APPLICATION NUMBER - SSD-67175465

173-179 Walker Street and 11-17 Hampden Street, North Sydney

Subject **Substantial loss of amenity due to view loss - Unit 1103 229 Miller St.**

Objector Jennifer ANDREWS

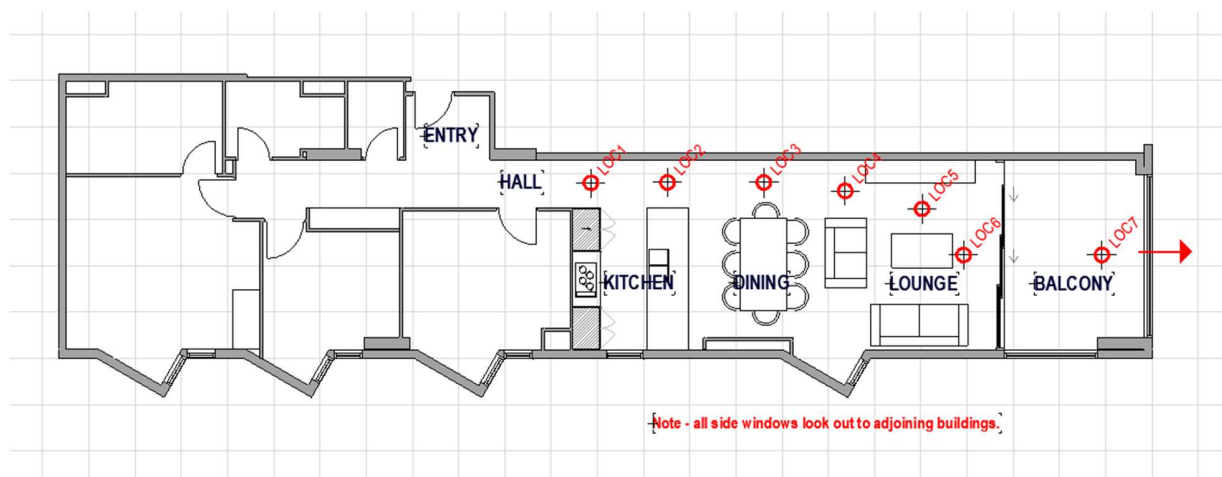
The photomontage on Page 108 of the Visual Impact Report is deceptive in that the photo it is based on was taken immediately adjacent to the external face of an enclosed balcony. This balcony is not full waterproofed and is not part of the functional internal living area of the apartment.

The Photomontage also does not reflect the actual impact on the amenity of the living areas in the apartment.

LOCATION 1

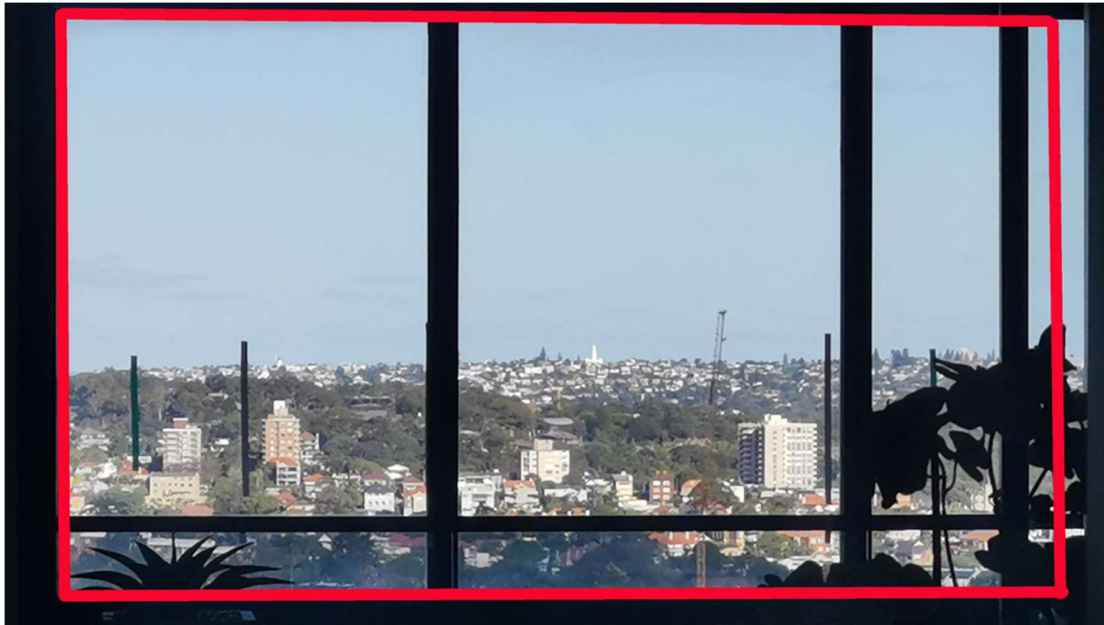
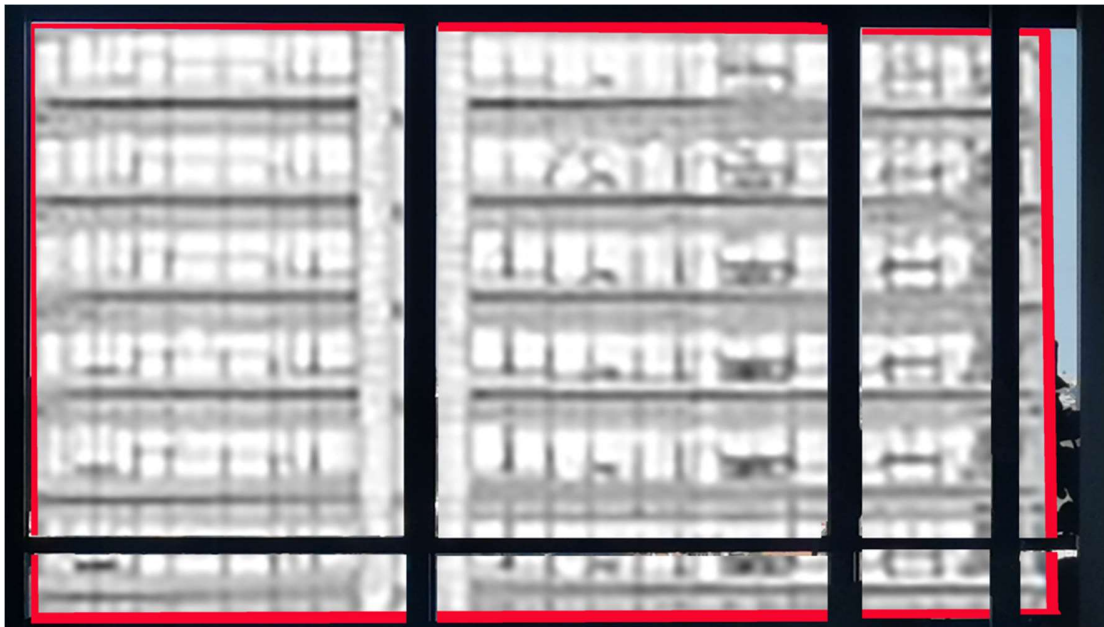
The camera point is located at the centre of the hall in line with the west side of the Kitchen.

Location 1 – Existing view with outline of new building

Location 1 – Impact of new building.

LOCATION 2

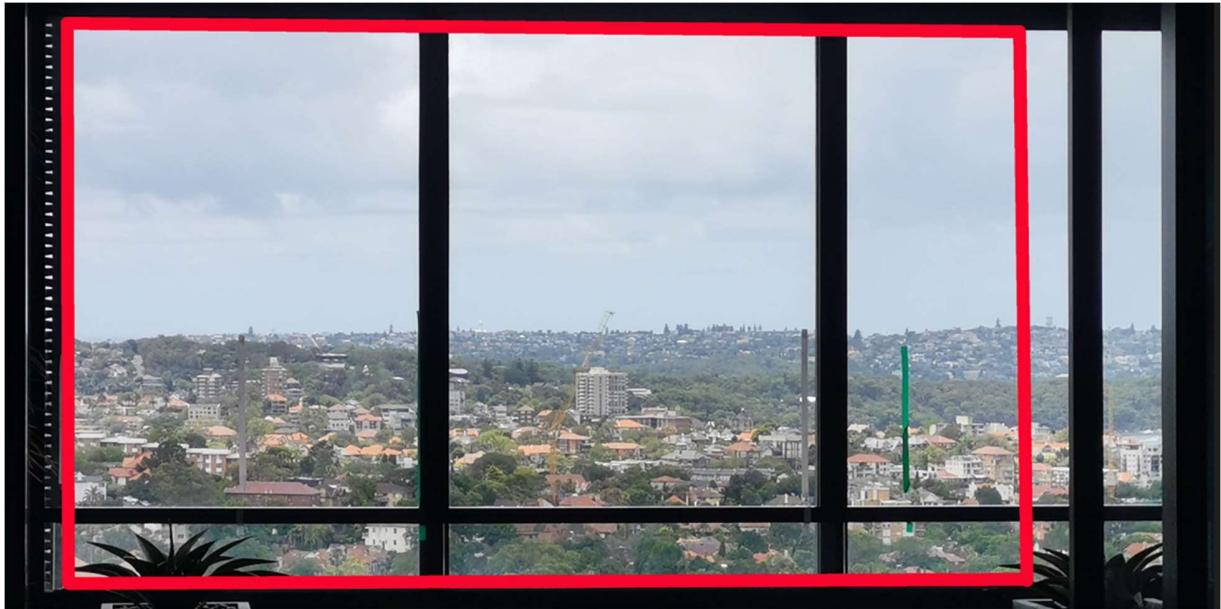
The camera point is located at the centre of the hall in line with the kitchen island bench.

Location 2 – Existing view with outline of new building

Location 2 – Impact of new building.

LOCATION 3

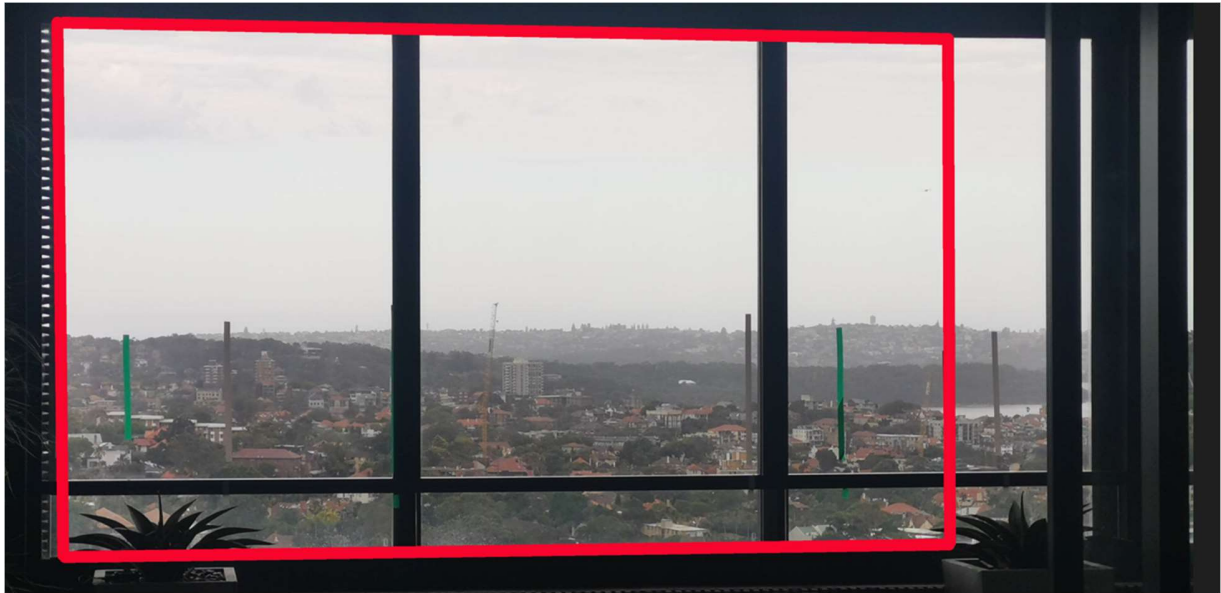
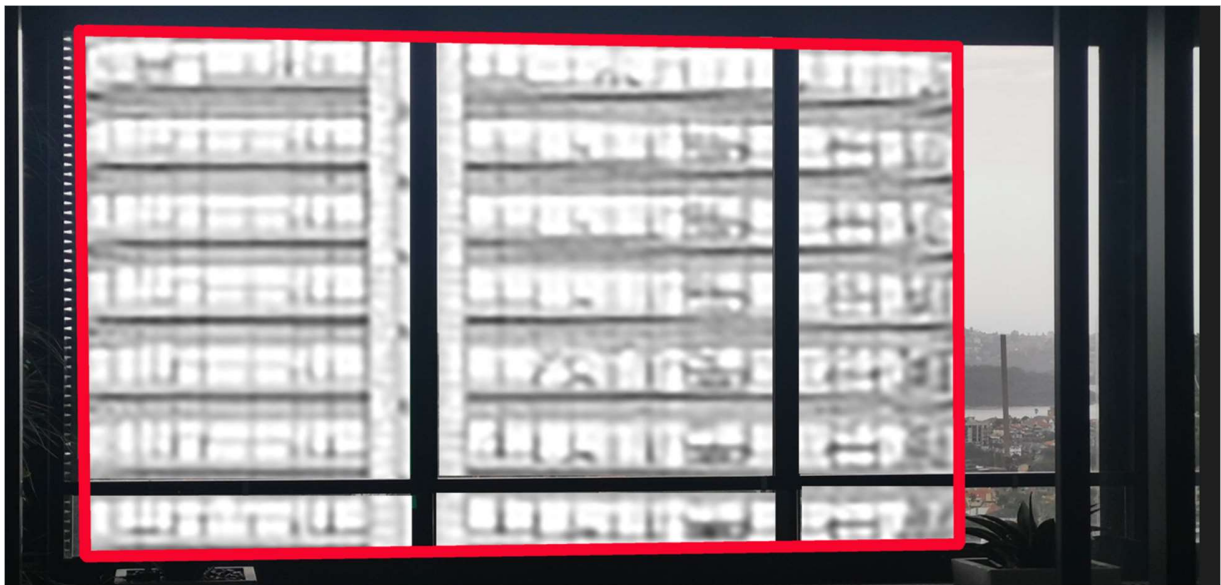
The camera point is located at the centre of the hall in line with the dining table. The dining table is heavily used on a daily basis.

Location 3 – Existing view with outline of new building

Location 3 – Impact of new building.

LOCATION 4

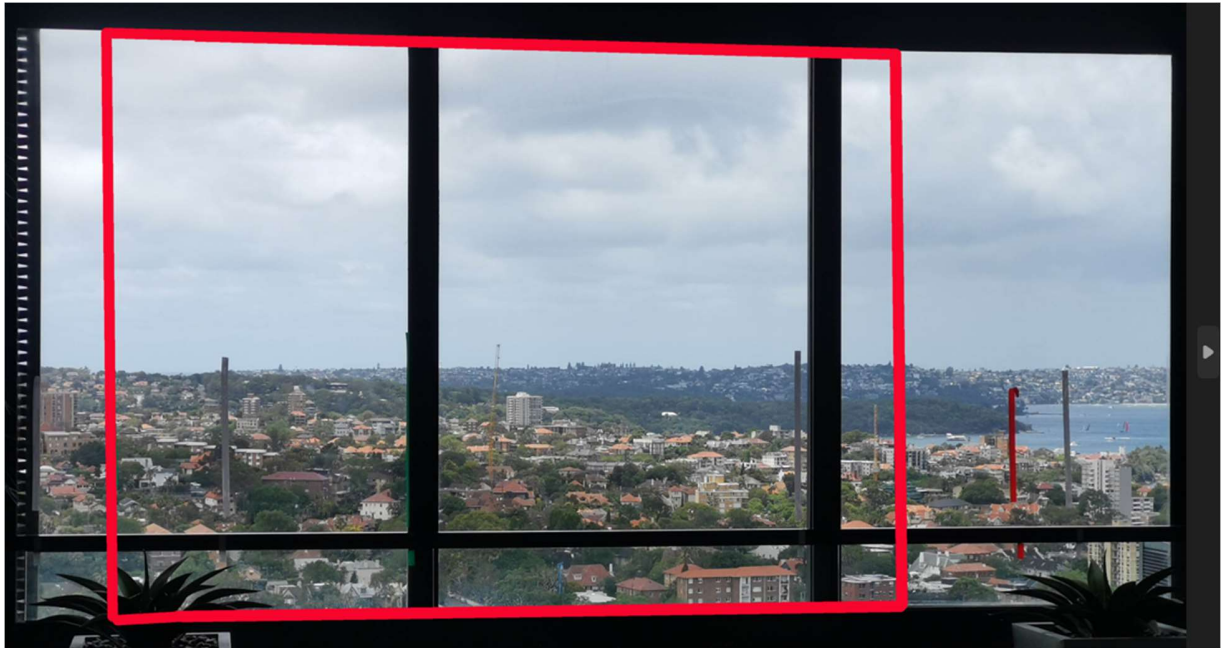
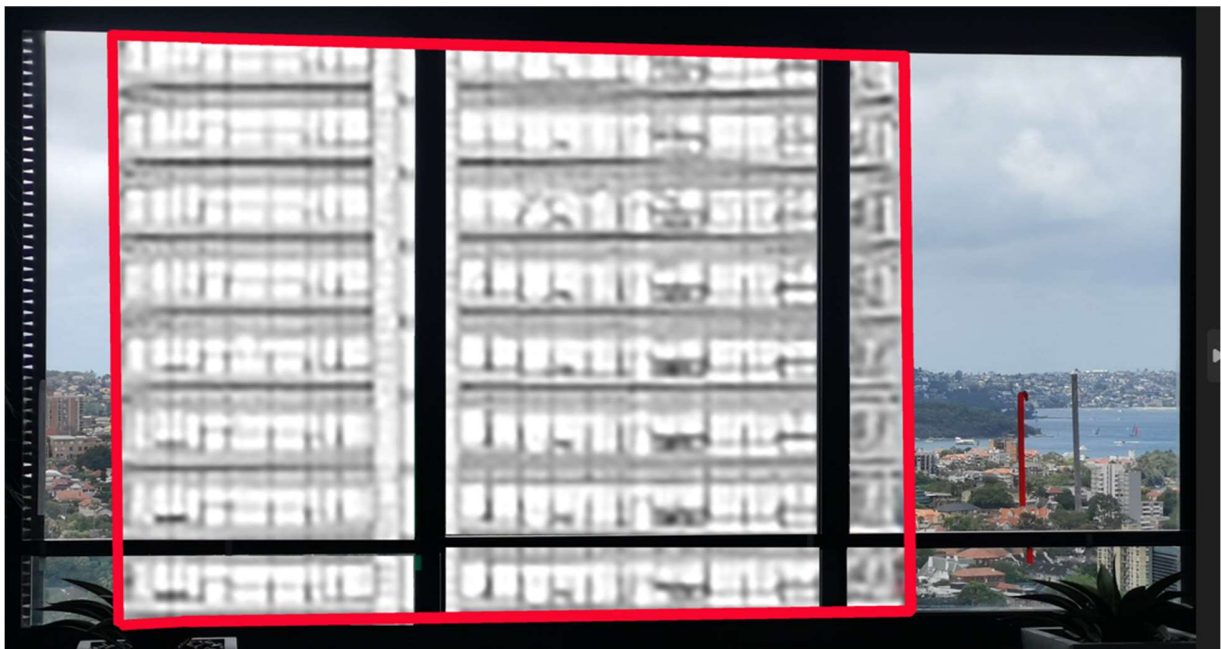
The camera point is located at the centre of the hall in line with the sofa.

Location 4 – Existing view with outline of new building

Location 4 – Impact of new building.

LOCATION 5

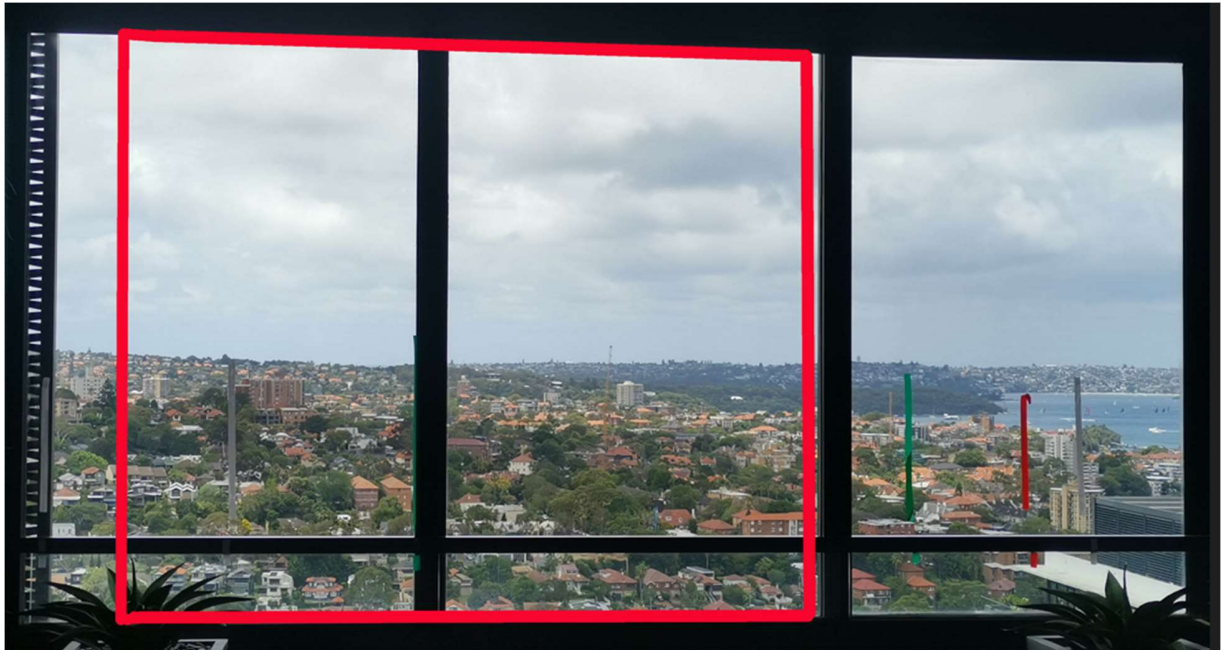
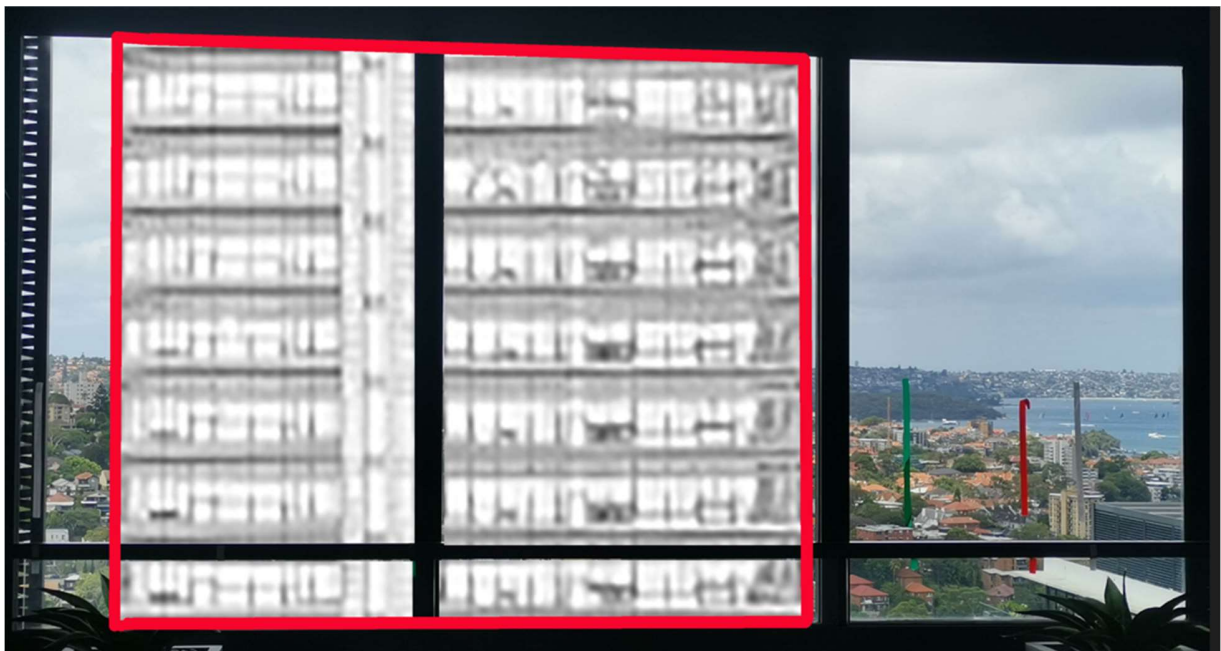
The camera point is located at the centre of the hall in line with the TV.

Location 5 – Existing view with outline of new building

Location 5 – Impact of new building.

LOCATION 6

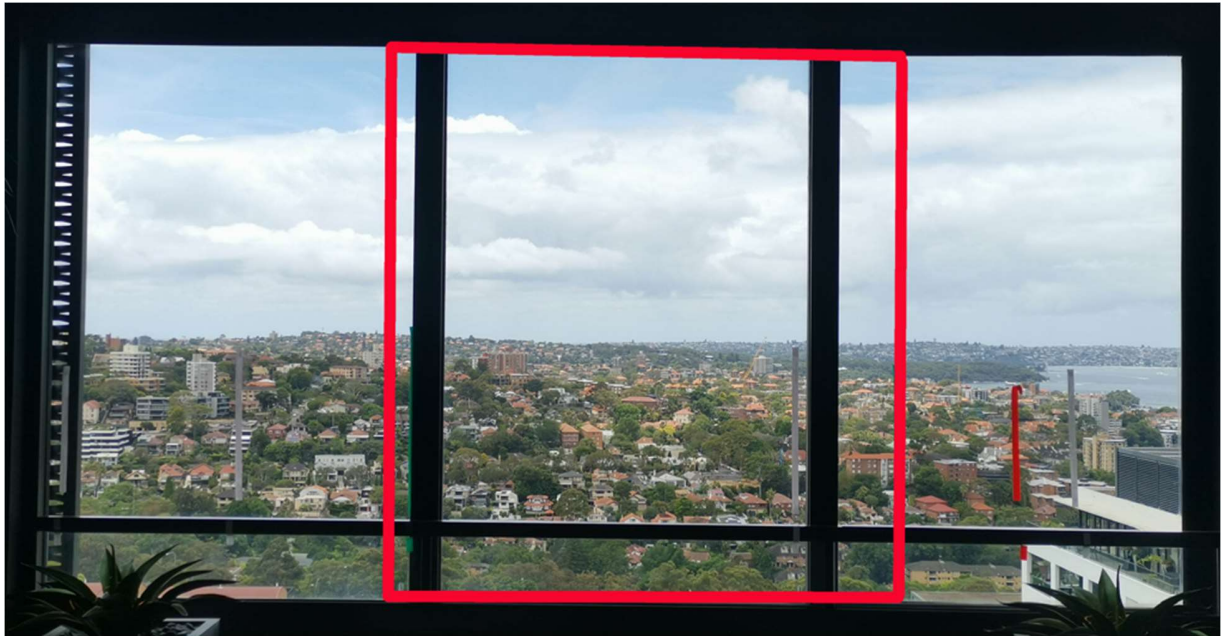
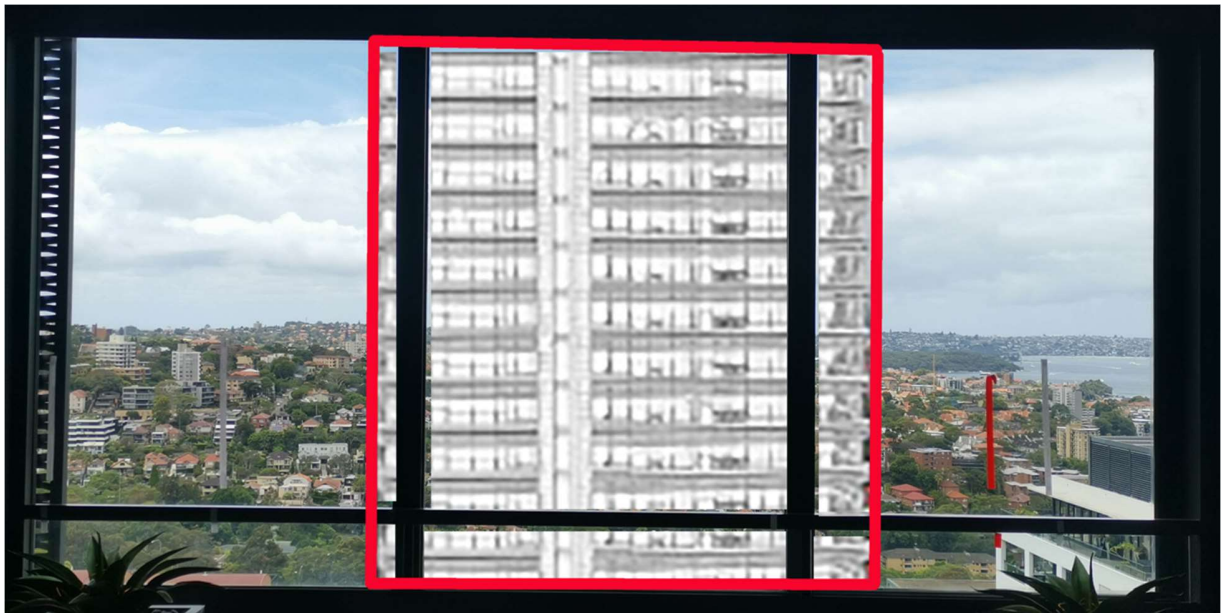
The camera point is located 1 m in at the centre of the sliding doors.

Location 6 – Existing view with outline of new building

Location 6 – Impact of new building.
